No. 222-05-173

Date Dec 08, 2005

MODEL AFFECTED: 222 and 222B

SUBJECT: LANDING GEAR ACTUATOR P/N 222-336-001-015, INTRODUCTION OF

Retract Actuator
Figure 1

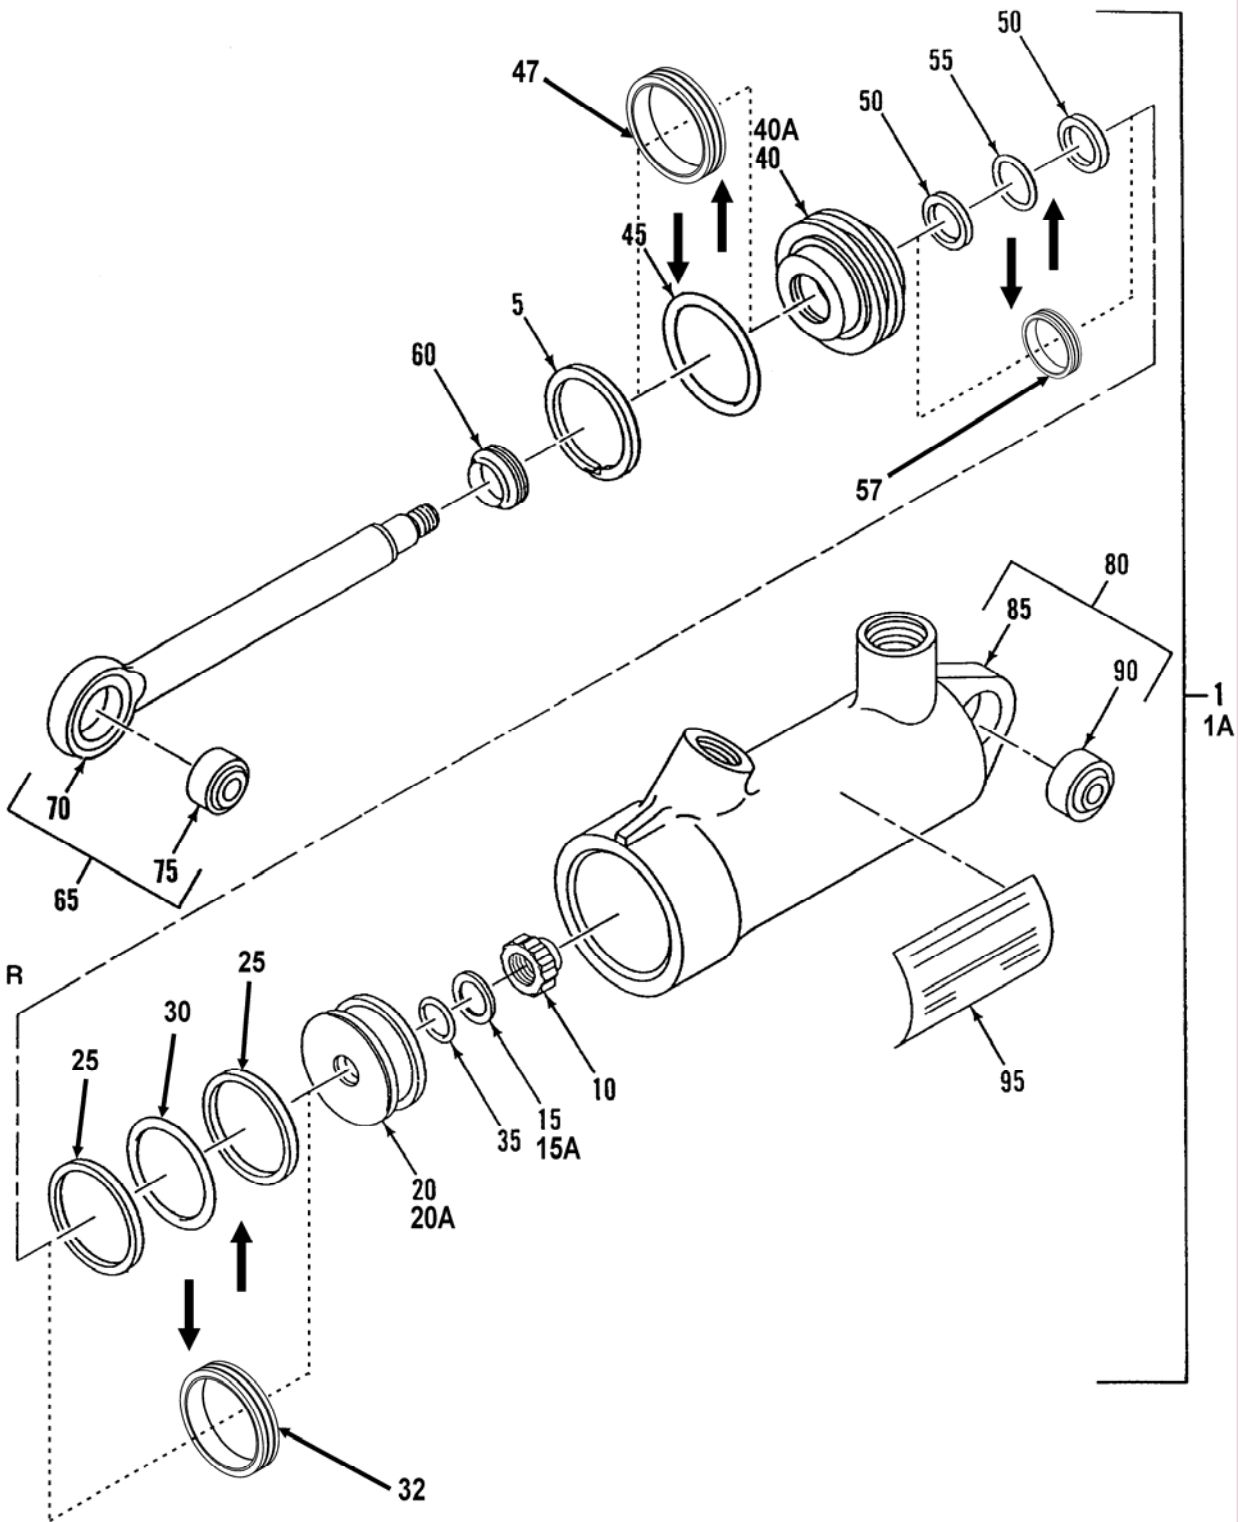
A new design actuator, interchangeable with the existing component, has been created. Improvements have been made to the dynamic seals as well as adding a friction reducing coating to the surfaces that are in contact during stroking of the actuator.

OMP3974-1 (Discard these items)	OMP3974-3 (Replace with these items)
Washer (15) Piston Head (20) Packing, Backups (25) (Qty of 2) Packing (30) Gland (40) Packing (45) Packing, Backups (50) (Qty of 2) Packing (55)	Washers (15A) (Qty of 3) Piston Head (20A) AGT Ring Seal (32) Gland (40A) AGT Ring Seal (47) AGT Ring Seal (57)

- (1) Inspect housing (85) bore ID as described in Table 801. Also, inspect for local deep wear marks near the entrance to the bore where piston head (20) made contact. If the locally concentrated depth is greater than 0.002 inches, then replace the housing. If the locally concentrated depth is between 0.0005 inches and 0.002 inches, then rework the housing as described in paragraph 5. If the locally concentrated depth is less than 0.0005 inches, then no repairs are necessary.
- (2) Inspect piston rod (70) OD as described in Table 801. Also, inspect for local deep wear marks near the threaded end of the OD where the gland (40) made contact. If there are scratches or scarring greater than 0.0005 inches deep on the .496/.498 OD, then rework the piston as described in paragraph 5. If there are no scratches, then no repairs are necessary.

- (1) Machine the housing bore ID to a maximum diameter of 1.434 inches.
- (2) Electrolyze the bore ID per MIL-DTL-23422, AMS2406 or AMS2438.
- (3) Finish dimensions to original manufacturing limits described in Table 801 and maintain surface finish of 16 rms or better.

- (1) Machine the rod OD to a minimum diameter of 0.488 inches to remove chrome plating.
- (2) Chrome plate the rod OD per AMS-QQ-C-320 (hard chrome).
- (3) Finish dimensions to original manufacturing limits described in Table 801 and maintain a surface finish of 16 rms or better.
